# WATER QUALITY MEMORANDUM Utah Coal Regulatory Program

April 15, 2010

TO: Internal File  
THRU: James D. Smith, Permit Supervisor *JDS 20 Apr 10*  
FROM: Steve Christensen, Environmental Scientist *SKC*  
RE: 2009, 1<sup>st</sup> Quarter Water Monitoring, Canyon Fuel Company (CFC), LLC, Dugout Mine, C/007/0039-WQ09-1, Task ID #3240

### DC-1: D-Na, TDS and Flow vs. Time

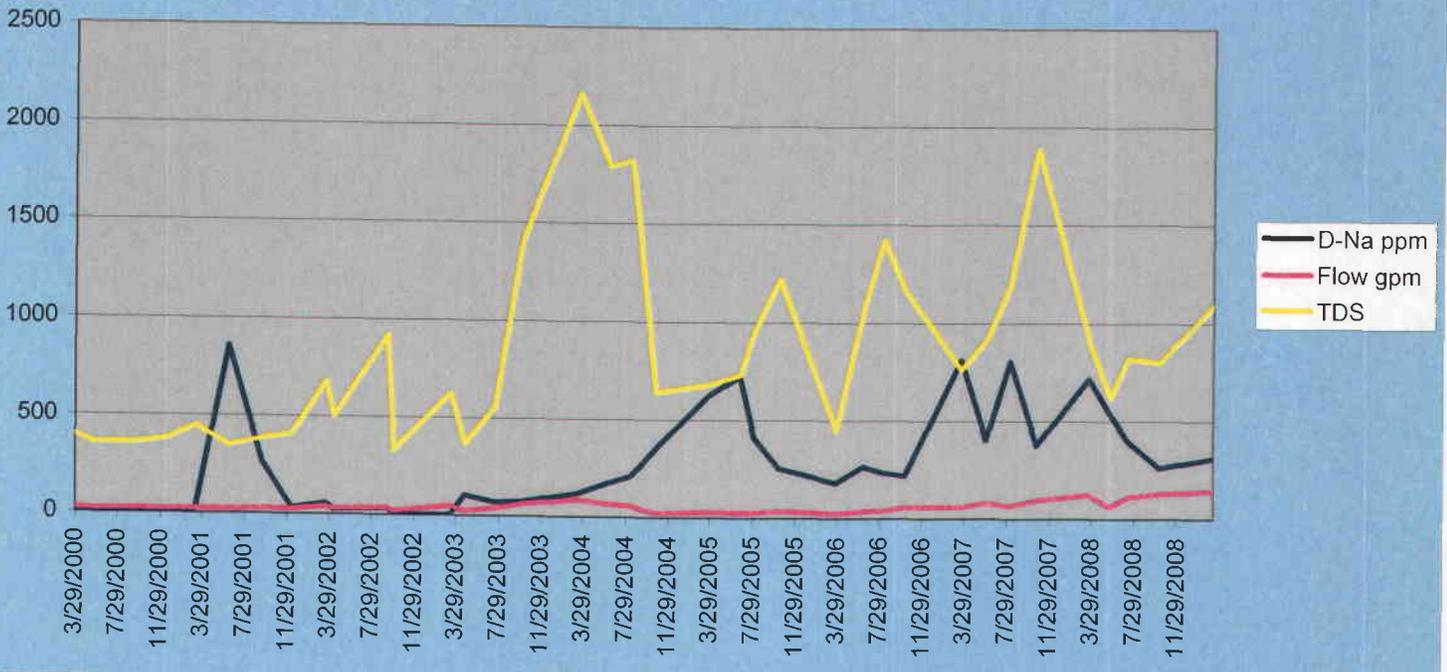
DC-1 reported a value of dissolved sodium (D-Na) that was outside of two standard deviations. This stream monitoring point has historically produced erratic D-Na values. Based upon the data set, it appears that the D-Na concentrations tend to spike during the spring and early summer, presumably as a result of snowmelt. (See Chart Below).
